**Permitting and Support Centre
Quadrant 2
99 Parkway Avenue
Parkway Business Park
S9 4WF**

Our ref: 3982-CAU-XX-XX-CO-V-9001-A0.C1

Your ref: *EPR/NP3538MF/V009*

Re: Schedule 5 notice for Daneshill Soils Treatment Facility (permit ref: EPR/NP3538MF/V009)

Figure 1. Water Treatment Schematic

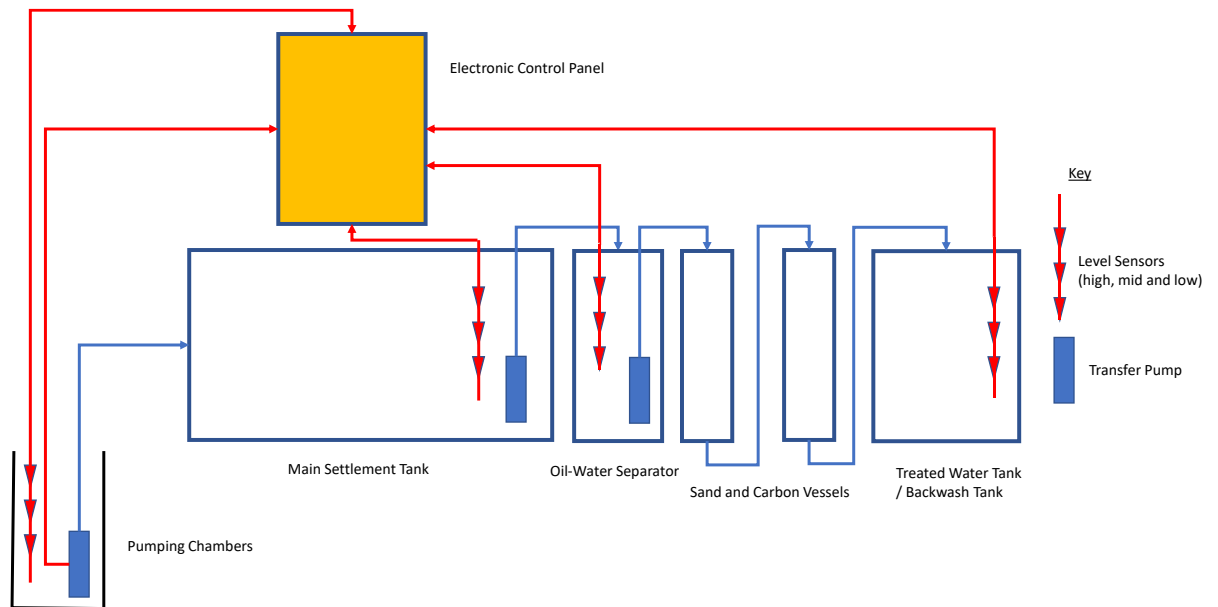
- 6) ***Explain any additional precautions proposed when dealing with water captured from the treatment pads including measures to prevent over pumping into the system.***

Waters captured from the treatment areas are pumped from the pumping chambers into the main water settlement tank. A schematic is shown in Figure 1 below.

The pumping system controls all the transfer pumps. The level sensors protect the pumps and protect from overfilling. The high level prevents further pumping into the receiving vessel. The mid-level activates the transfer pump. The low-level sensor prevents the water level from being below the level of the transfer pump.

The main water settlement tank is installed with low level, mid-level and high-level sensors. If the high-level sensor is activated the control panel will prevent further pumping from the treatment areas into the main settlement tank. The mid and high-level sensors operate the settlement tank pump which transfers water through the sand and carbon filtration tanks to the treated water tank. The transfer pump in the main settlement tank will continue to pump until the water level reaches the low-level water sensor. However, if any of the high-level water sensors are activated the control panel will prevent further water to be pumped into the vessel.

The pumps in the collection sumps cannot pump water until water levels in the main settlement tank are below the high level. When the water level reaches the mid-level sensor the pump shuts down.

In addition to the level sensor protection of the tanks, there is a bund surrounding the water treatment system that also provides over pumping protection.

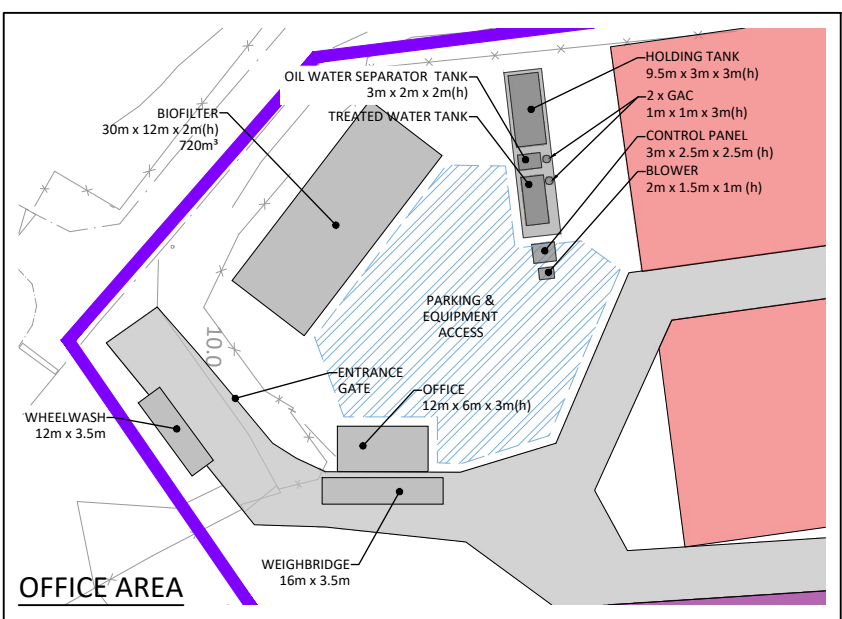
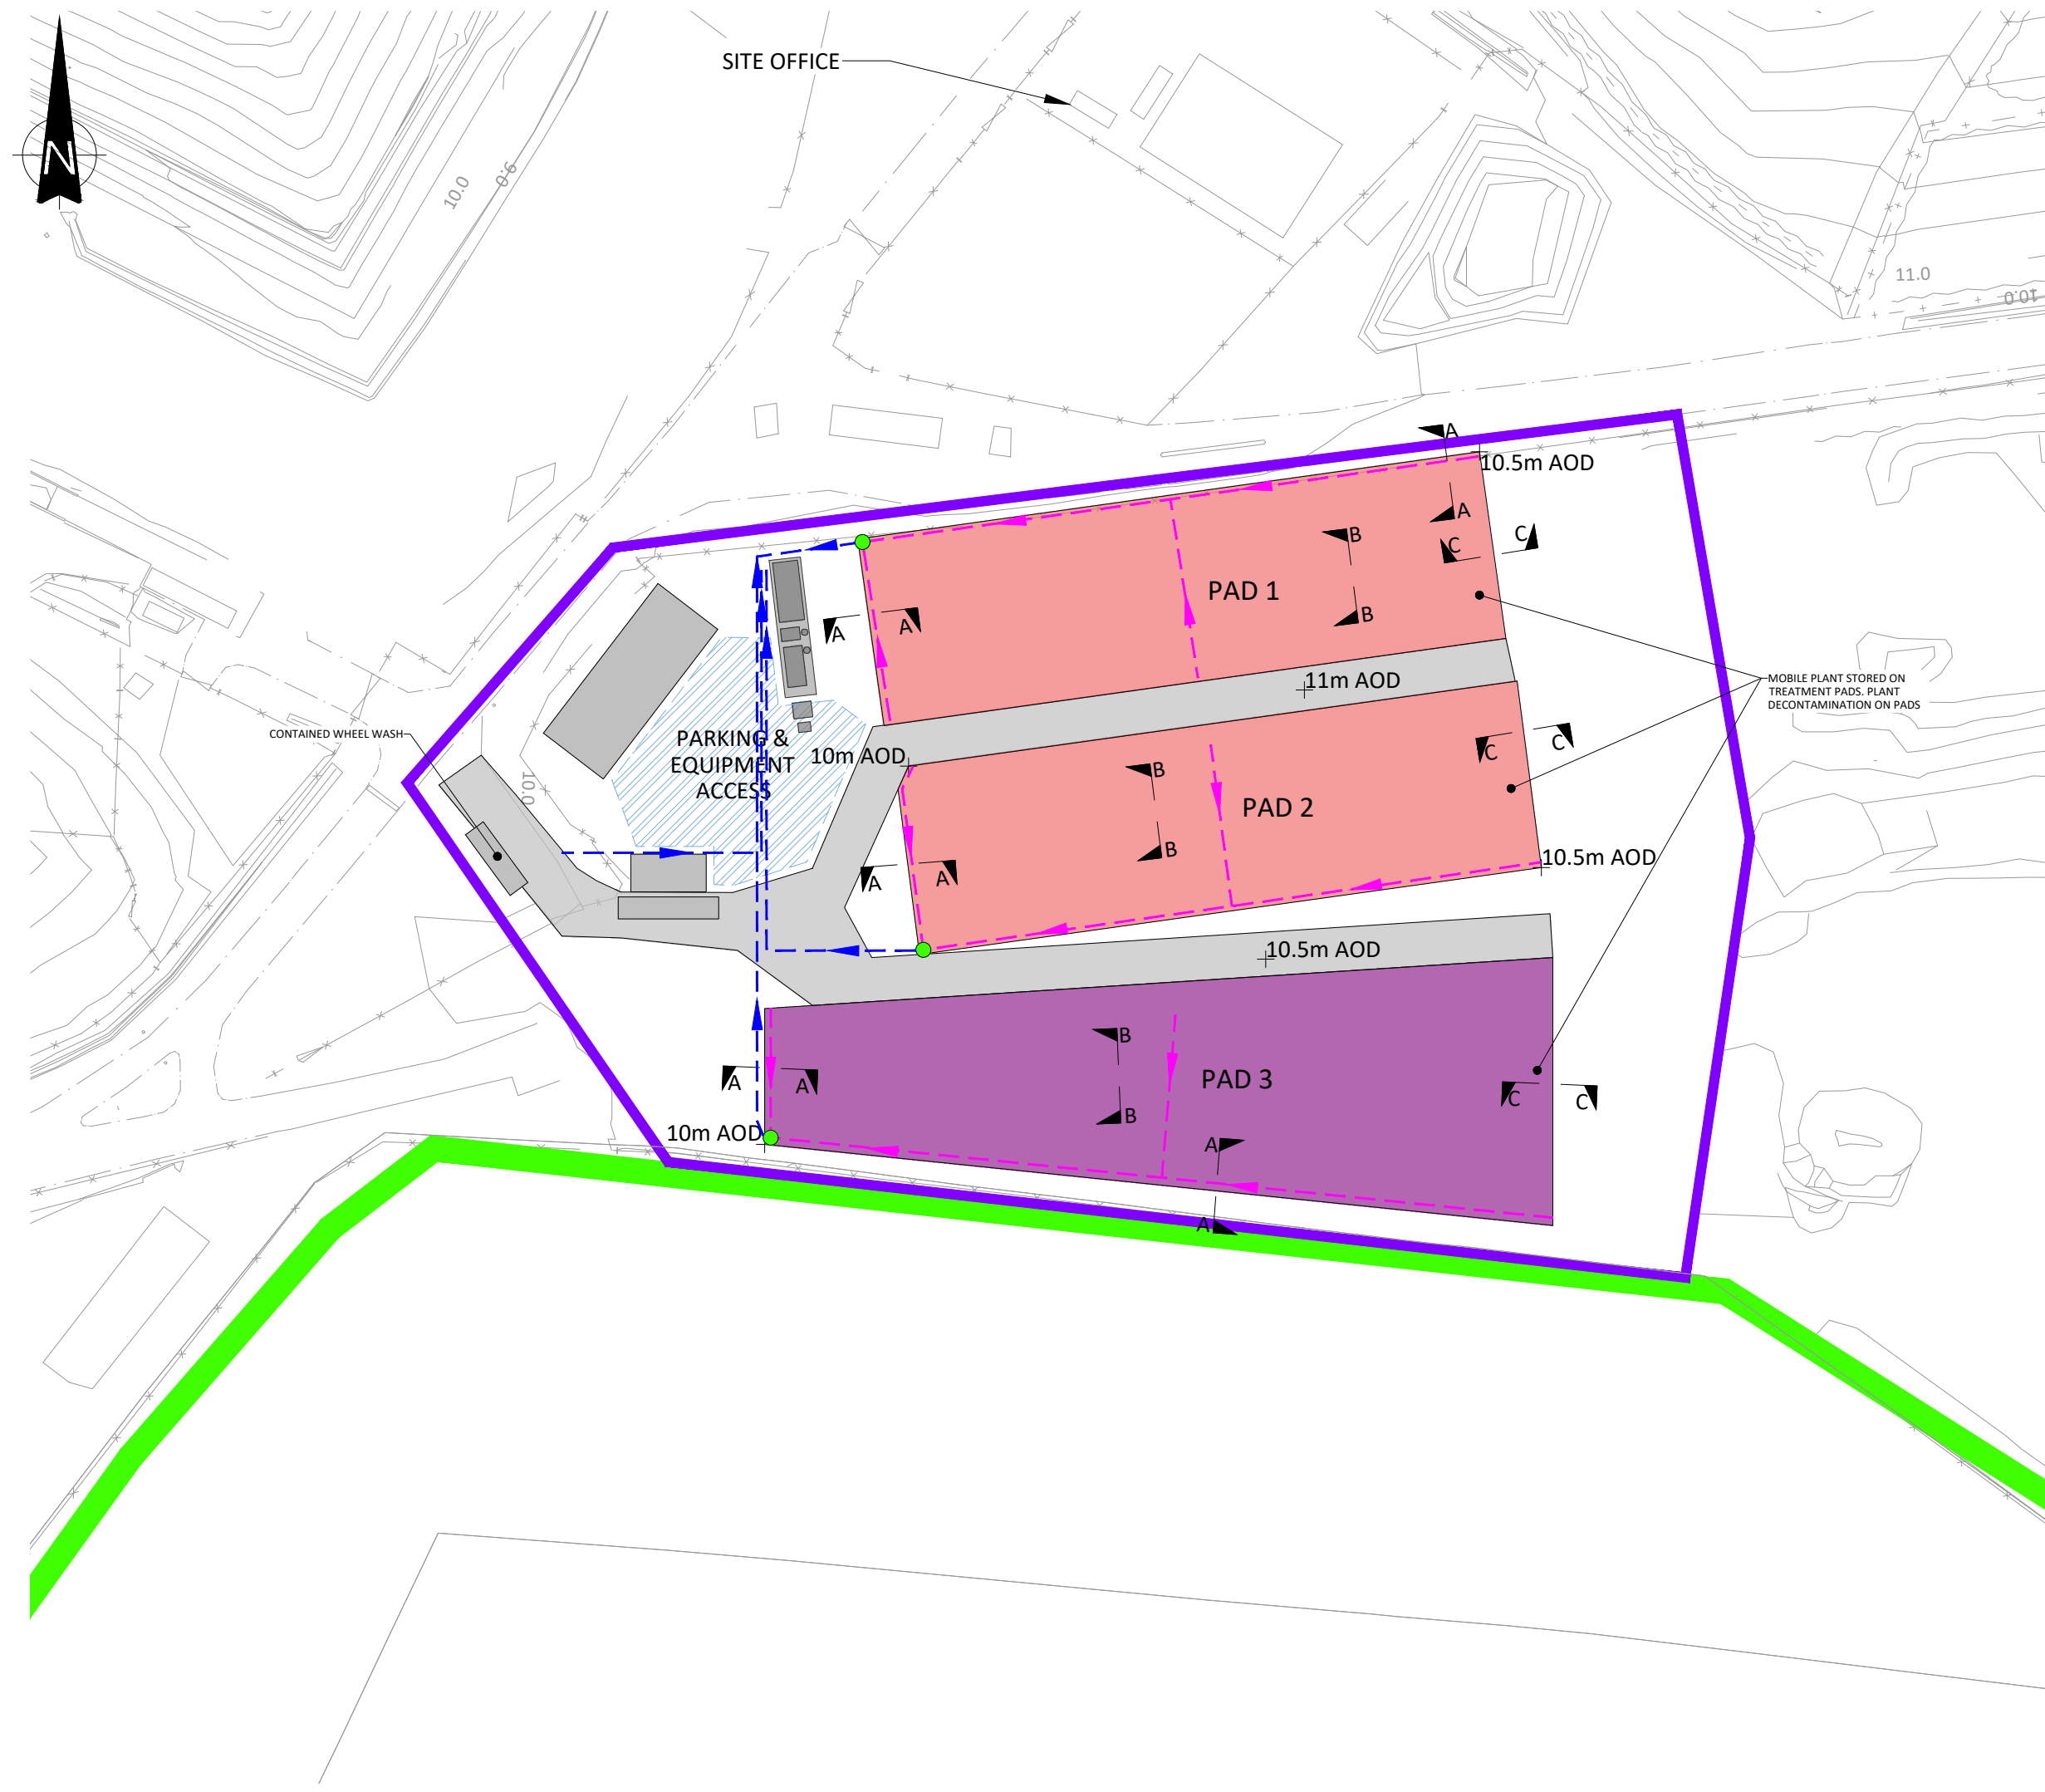
Provide a revised site layout plan which shows the site infrastructure in great detail. The plan must be labelled and to scale and show how the site has been designed to ensure segregation of hazardous and non-hazardous waste along with asbestos contaminated soils. As a minimum it must include:

- Waste stockpile locations
- Raw materials and fuels (including bunding)
- Key plant items such as screening plant and asbestos picking station (show how conveyors with inputs both in and out)
- Asbestos storage skips
- Vehicle wheel wash
- Storage of mobile plant such as excavators
- Asbestos decontamination areas and control zones
- Equipment wash down areas
- Water treatment compound
- Biofilter

Please see attached drawing ref: 3982-CAU-XX-XX-DR-V-1807 'Soils Treatment Pads; 1,2 and 3 Site Layout Plan'

PROJECT:						
DANESHILL SOILS TREATMENT FACILITY						
TITLE:						
SURFACE AND FOUL WATER LOCATIONS						
DESIGNED BY	DRAWN BY	REVIEWED BY	AUTHORISED BY			
KB	EJD	KB	KB			
DATE	SCALE @ A3	JOB REF:	REVISION			
29.09.2021	1:1000	3982	P01			
DRAWING NUMBER						
3982-CAU-XX-XX-DR-V-1808

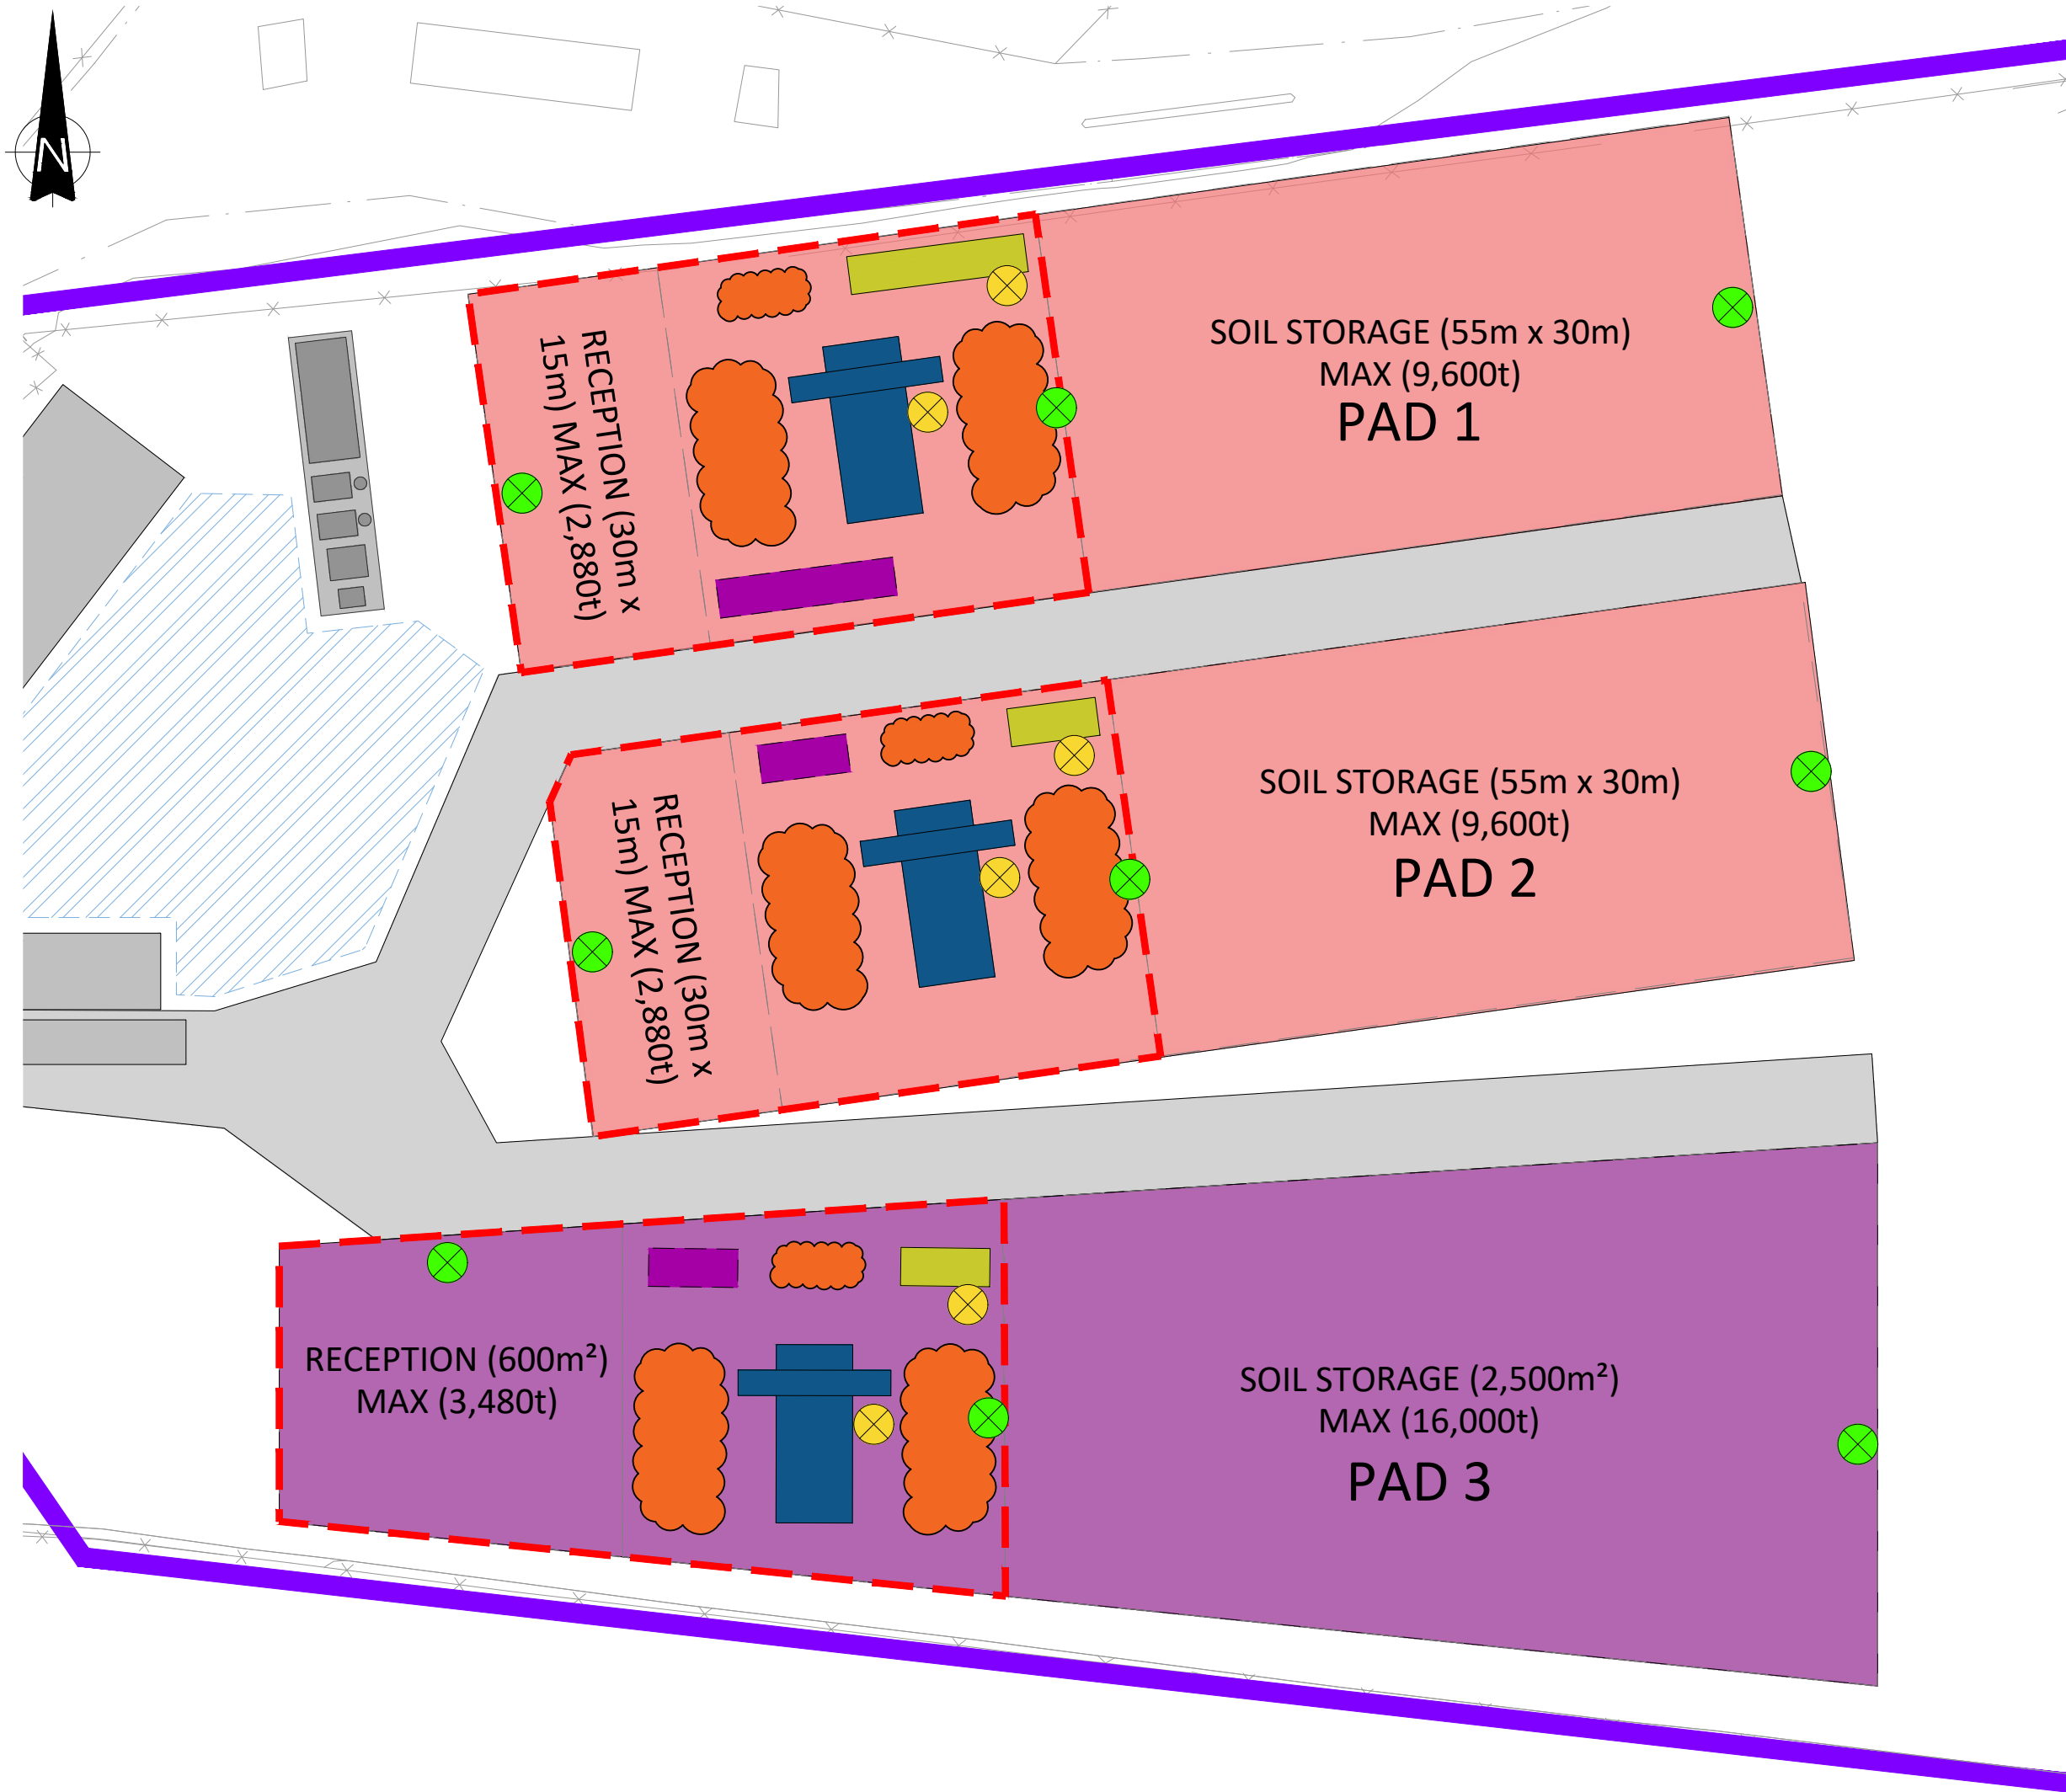
- 2) ***Provide a revised drainage plan which shows how waters falling onto the wider site are captured and channelled. Site surfacing must be labelled and the location of the vehicle wheel wash and equipment wash-down areas shown along with an explanation of how these water are captured and contained. The plan must show any surface water discharge points from the STF area.***

- 3) ***Explain how the asbestos storage and treatment pad will be designed to ensure that surface water falling on the pad will be retained and channelled to the collection sump.***

Please see attached drawing ref: 3982-CAU-XX-XX-DR-V-1808 'Surface and Foul Water Locations'

Please see attached drawing ref: 3982-CAU-XX-XX-DR-V-1808 'Surface and Foul Water Locations'.

Treatment pads are designed to have a fall towards a main water collection drain to ensure that water is continually drained from the pads and directed towards a centralised pumping chamber for transfer to the water treatment system. Water is unable to leave the downgradient periphery of the pads by lateral flow due to the presence of a containment bund of 300mm height. Water is unable to migrate to underlying controlled waters due to the presence of an engineered pad with a geosynthetic clay liner that would have a design permeability of 1×10^{-9} m/s as a minimum.
